LETTER REPORT ON THE
REVIEW OF THE SEQUENCES
FOLLOWING A RELEASE OF EXCESSIVE WATER IN
ELEVATION 8 OF THE REACTOR BUILDING IN THE
SHOREHAM NUCLEAR POWER STATION

K. Shiu
Y. Sun
E. Anavim
I. A. Papazoglou

Risk Evaluation Group
Department of Nuclear Energy
Brookhaven National Laboratory
Upton, New York 11973

April 1984

Figure 3.2.1 Problem-solving human error probability vs time - screening values.

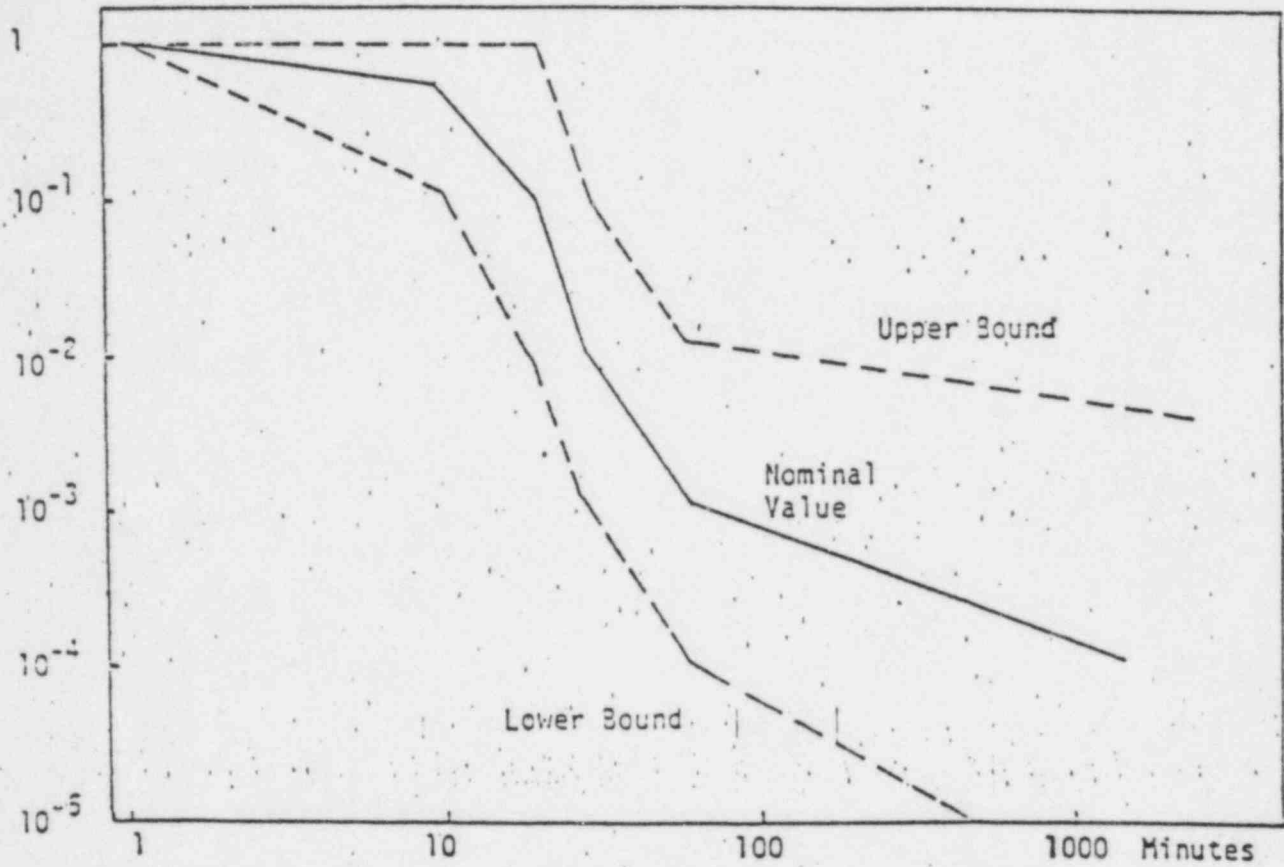
The HEP values used by SNPS are identical to the nominal HEP values provided in the Probabilistic Risk Analysis Procedure Guide⁽⁷⁾ (see Figure 3.2.1 and Table 3.2.3). BNL feels that the HEP could be higher than the nominal HEP values because the flooding alarm related procedures fail to provide specific guidelines to identify and to isolate the flood source (see Section 3.2.1).

Figure 3.3.1 Phase I of Internal Flood Functional Event Tree

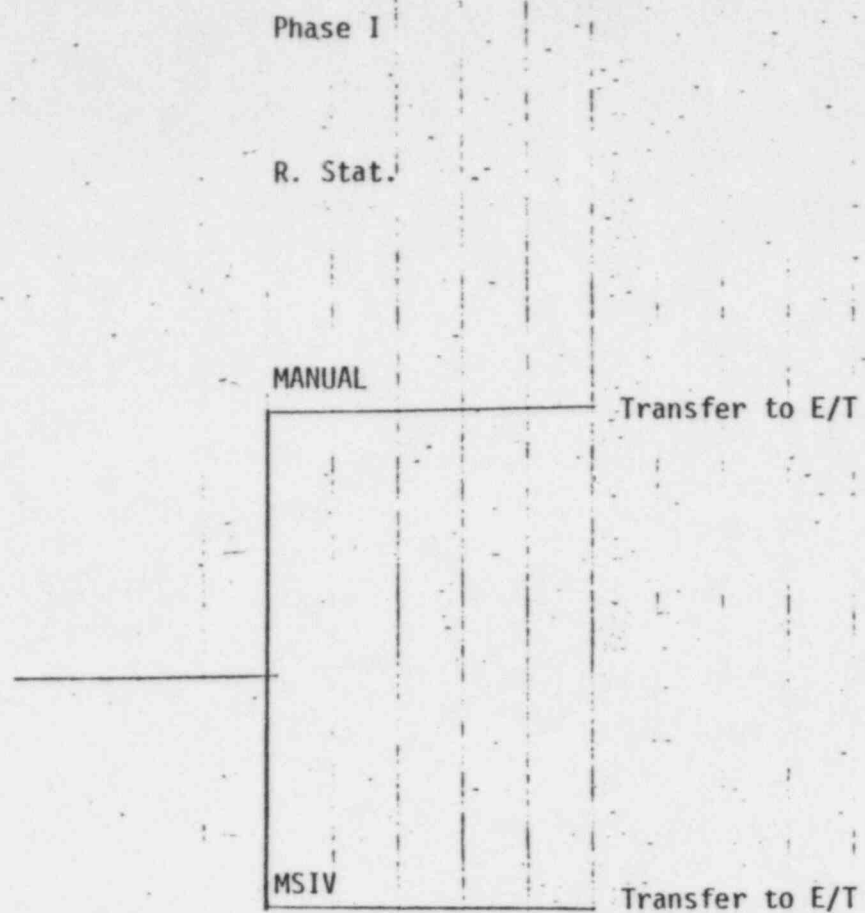
The event trees of these four phases are presented in Figures 3.3.1 through 3.3.4. Given that the flood is terminated in Phase I, BNL assumed that the reactor has a high probability (0.9) that it will be manually shutdown. Ten percent of the time, it may result in a MSIV closure event. These two branches of the Phase I event trees are transferred to the respective internal event tree, Figure 3.3.1.

Figure 3.3.2 Phase II of Internal Flood Functional Event Tree

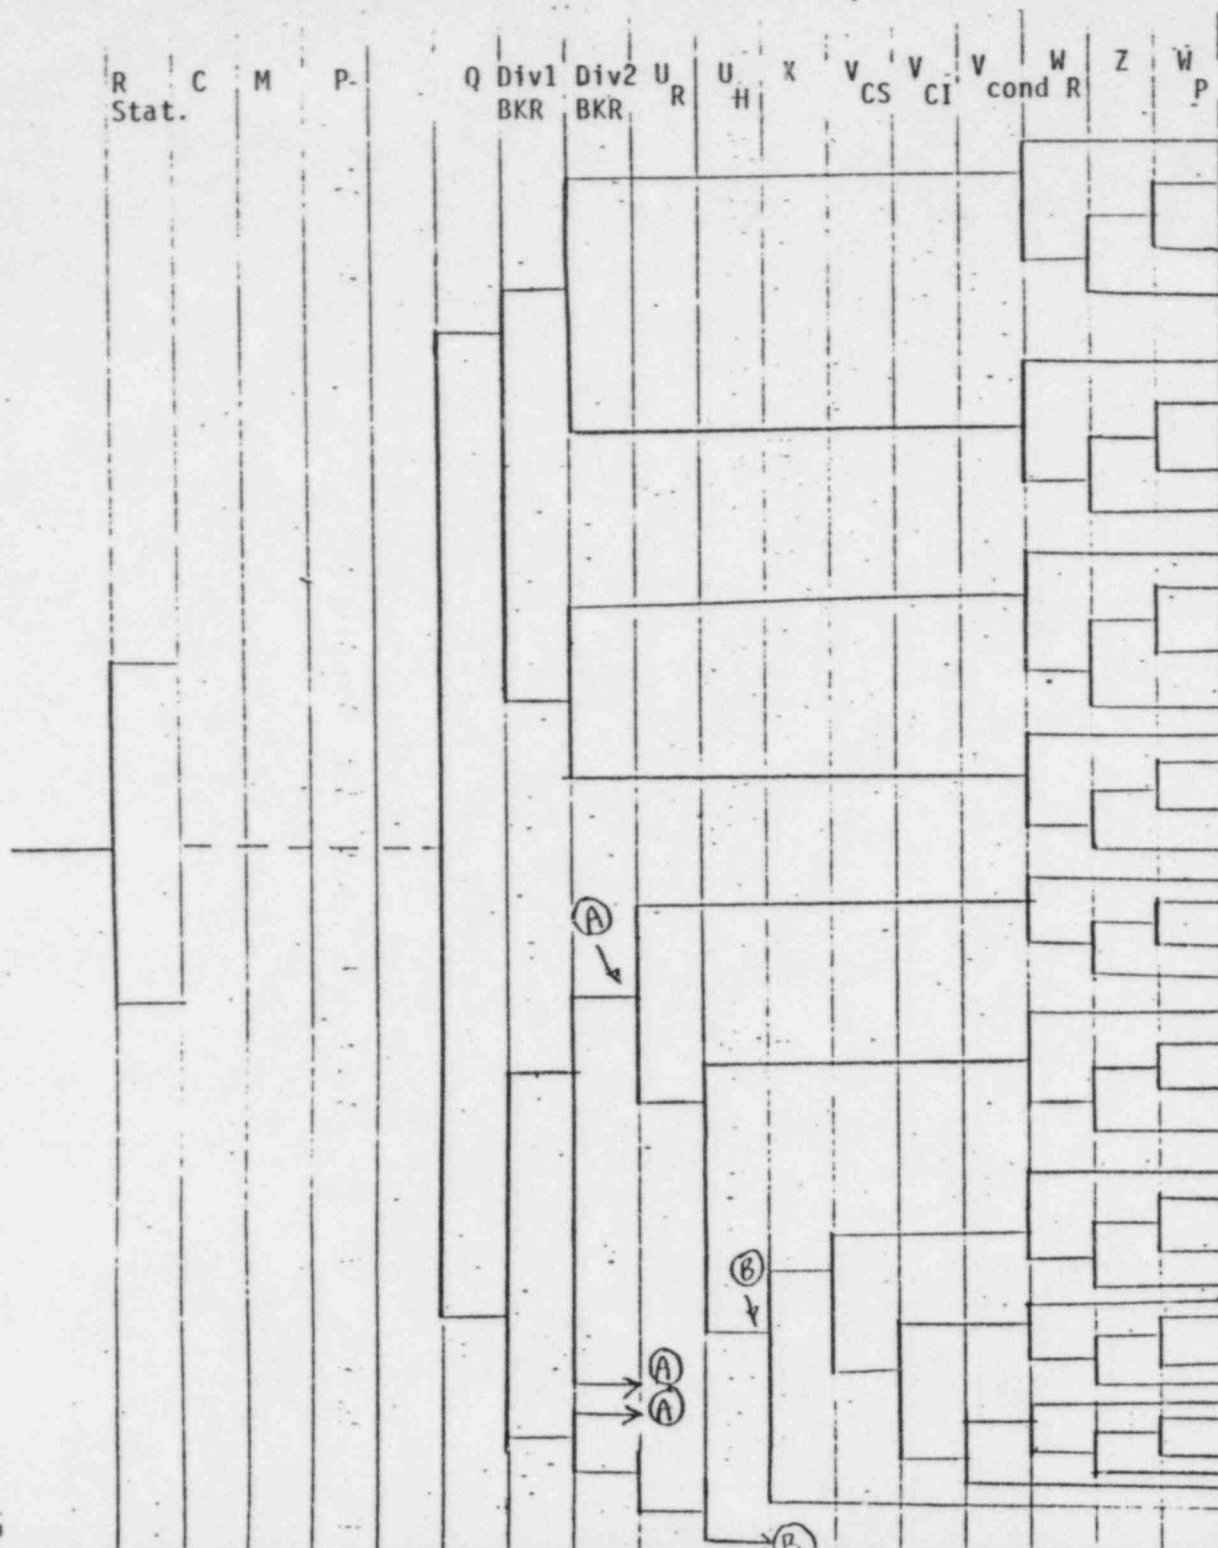
Figure 3.3.2 depicts the Phase II functional event tree which considers the various accident mitigation systems. Moreover, owing to the fact that a number of the 480V pumps will be flooded, the possibility of a breaker failure to isolate the fault is also evaluated. It is assumed that the breaker failure to open probability is 1×10^{-3} and there are a total of five pumps in Division I and two pumps in Division II that will be short circuited. A probability of 0.5 is also assumed that failure of a load center in a division would lead to failure of other equipment connected to that division. In the event of a MSIV closure, the feedwater system is considered to be unavailable. The probability that the reactor will be manually shutdown is also assumed to be 0.9 for the maintenance induced flood events.
